Product Change Notification

Change Notification #: 113114 - 00
Change Title: Intel® Spare Power Distribution Board
FUPPDBLC
PCN 113114-00, Product Design
Change Capacitor and Cable
Date of Publication: June 30, 2014

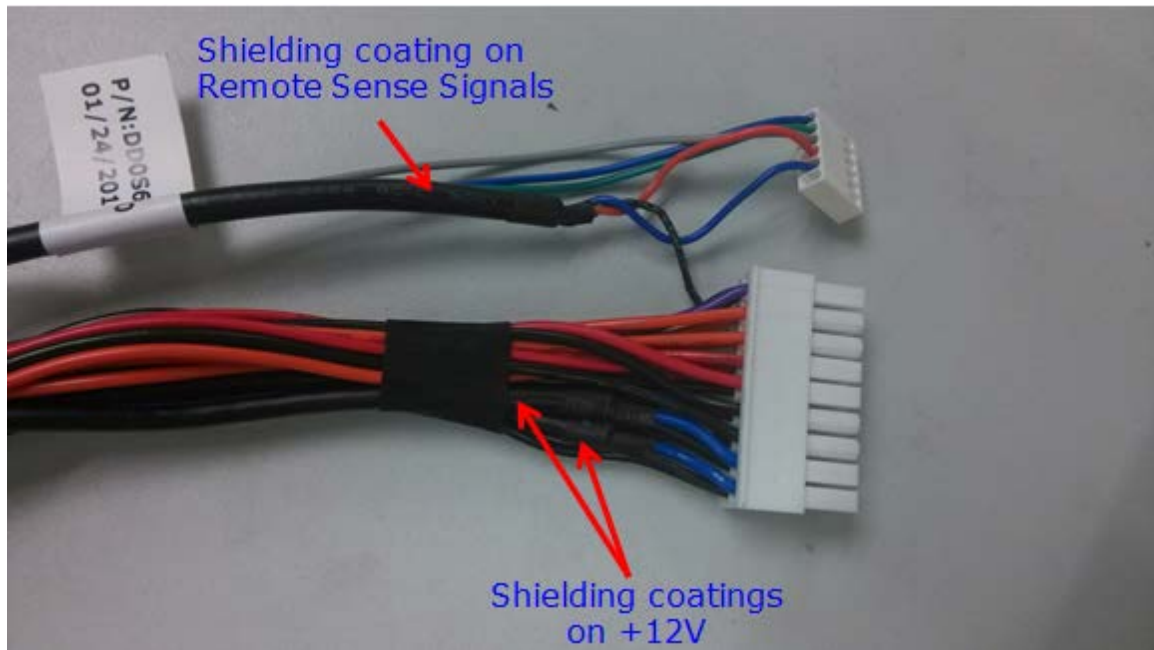
1. Increase the capacitor values of C11 and C13 from 0.1 μ F to 2.2 μ F to extend the duration of the Over Current Protection circuit from 0.6ms to 8.0ms. Please refer to the TA-1056-01 for more details.
